# Technical Service Bulletin

## 20 Noises from the fuel line

20 24 66 2059997/5 February 19, 2024. Supersedes Technical Service Bulletin Group 20 number 23-53 dated January 31, 2023 for reasons listed below.

**Figure 1.** Location of the vibrating fuel line.

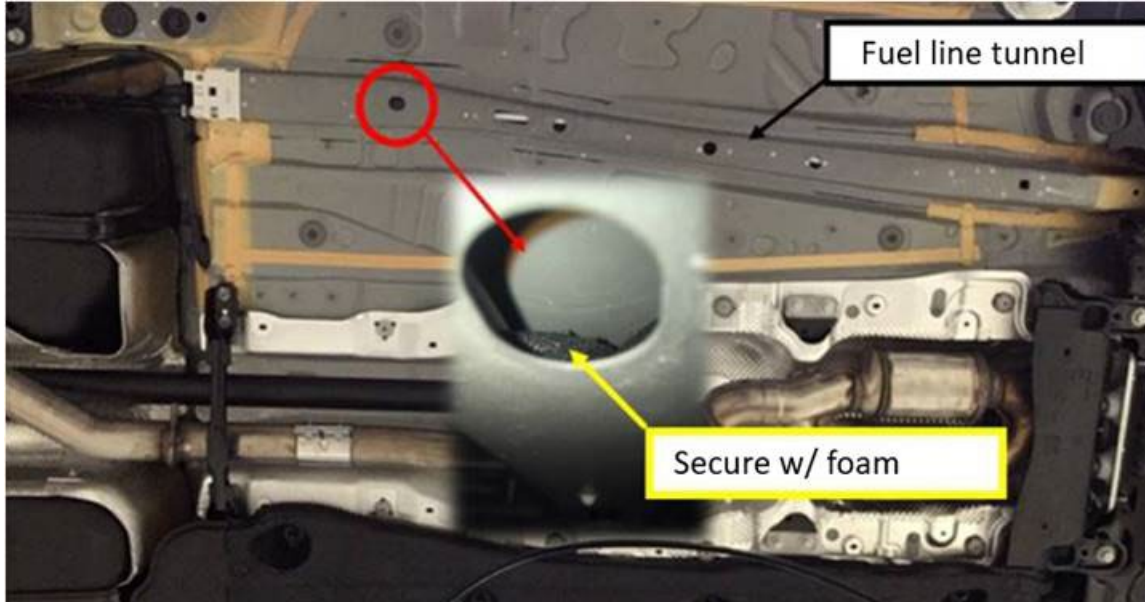
2. Install closed-cell foam (foam that doesn't soak up water) part number 321 201 299 on the fuel and EVAP line tunnel or fill the space around the fuel and EVAP lines. The fuel/EVAP line does not have to be removed. If this does not work, then install a toothed lock washer 06A 141 730 A.

**Figure 2.** Felt installation location, between tank and fuel line.

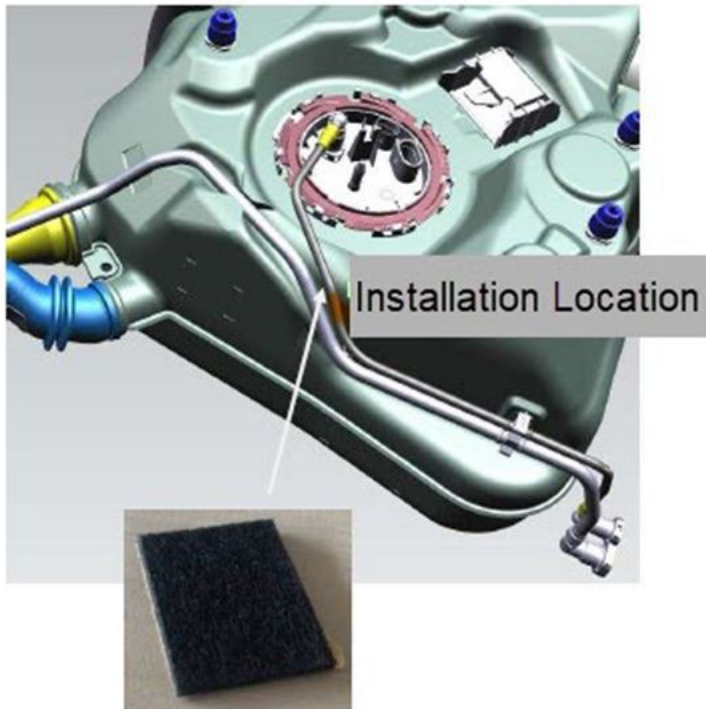
3. Reinstall the underbody cover.
4. Please use a felt piece 4B0 857 579. Attach it to the fuel tank as shown in the image below (Figure 2).
